New Alternator Pulley and Belt

Binder - Service Technical Bulletins
This Bulletin replaces bulletin,
Group 1, # 7/97, dated 7-10-97.

Vehicle Type: **911 Carrera as of M.Y. 1995 and 911 Turbo as of M.Y. 1996**

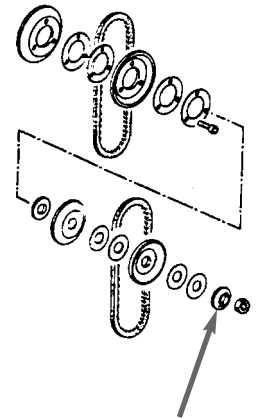
Concern: In case of alternator belt failure or belt noises in conjunction with pulley, part number, 993 106 268 00 (s/s to 993 106 268 01), the alternator belt and pulley must be replaced.

When installing the new version pulley halves on the 911 Carrera and Turbo, the distance spacer, (see arrow, illustration) is machined as part of the new version pulley and is no longer required. Because of this, it is no longer possible to store adjustment shims behind the distance spacer on the outside of the alternator pulley. Shims removed during the tensioning procedure should be stored in the vehicle tool kit. The tensioning procedure can be found in Repair Group 13, page 13 - 32.

Information: **911 Turbo:**
When repairs are necessary, install only the new version belt and pulley halves.

The new version pulleys can also be installed on the 911 Carrera. However, the previous version belt must be used.
